**EXPLANATION OF SIGNIFICANT DIFFERENCE FOR THE
FINAL RECORD OF DECISION FOR INSTALLATION
RESTORATION SITE 1 SOIL COVER**
*Installation Restoration Site 1
Alameda Point, Alameda, California*

Document Control Number: AMEC-8816-0002-0182

April 2013

Figure 3a. Selected Remedy

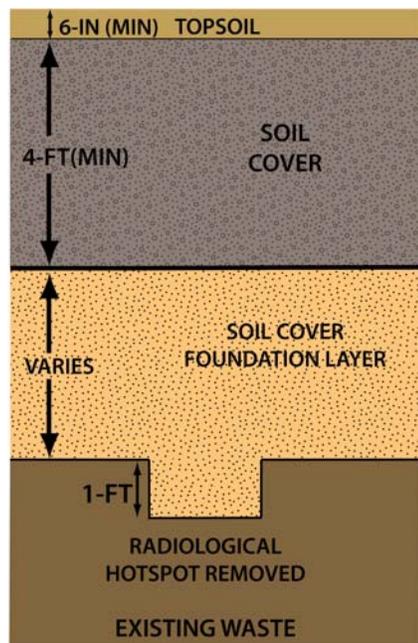
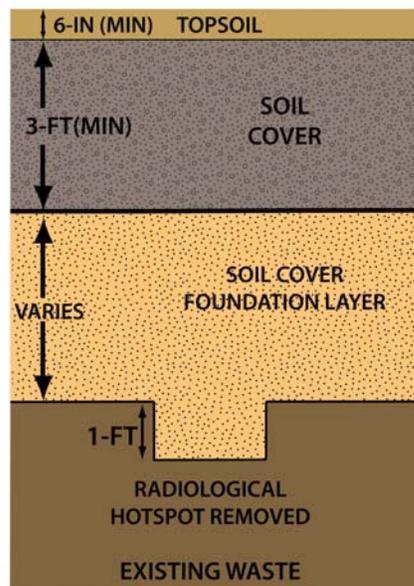
The proposed change in the soil-cover remedy is illustrated in Figures 3a and 3b below:

Figure 3a shows the current soil cover remedy; Figure 3b illustrates the proposed revision to the soil cover remedy

8	<p>The selected remedy illustrated in Figure 3a, Selected Remedy, does not reflect the soil cover remedy proposed in the ROD. The selected remedy in the ROD includes the removal of radiological hot spot material to a depth of one foot if the material exhibits gamma radiation readings approximately two times background similar to the proposed revision to the selected remedy, as presented in Figure 3b, Proposed Revision to Selected Remedy. This would have resulted in a four-foot thickness of clean soil over most areas and a five-foot thickness in areas with radiological hot spots that have been removed. The revision to the selected remedy is thus directly related to the soil cover thickness. Please revise Figures 3a and 3b to more accurately reflect the selected remedy in the ROD and the proposed revision to the selected remedy presented in the Draft ESD.</p>	<p>Figure 3a was edited to reflect the removal of hot spots in the remedy selected in the ROD, showing a 5-foot thick cover of portions of the cover where a hot spot was removed, as the reviewer requested.</p>

This ESD documents a change in the thickness of the soil cover of the selected remedy from 4 feet to 3 feet over areas of IR Site 1. The installation of a 3-foot soil cover, following the surface scan and hot spot removal to a depth of 1 foot, will create a 4-foot barrier between potentially radium-impacted waste and the surface of the closed landfill. As described in Appendix A to the Feasibility Study, an evaluation of a hypothetical radium-226 source within the landfill demonstrated that a 2-foot soil cover would yield a risk which was within the CERCLA risk range and that a 4-foot soil cover would reduce that risk by two orders of magnitude. Because the scan to be conducted in connection with the preparation of the foundation layer will identify and remove radiological contamination which exceeds 2 times radiological background in the top foot of the foundation layer, the modified remedy will provide 4 feet of soil cover and achieve the objective of the selected remedy.
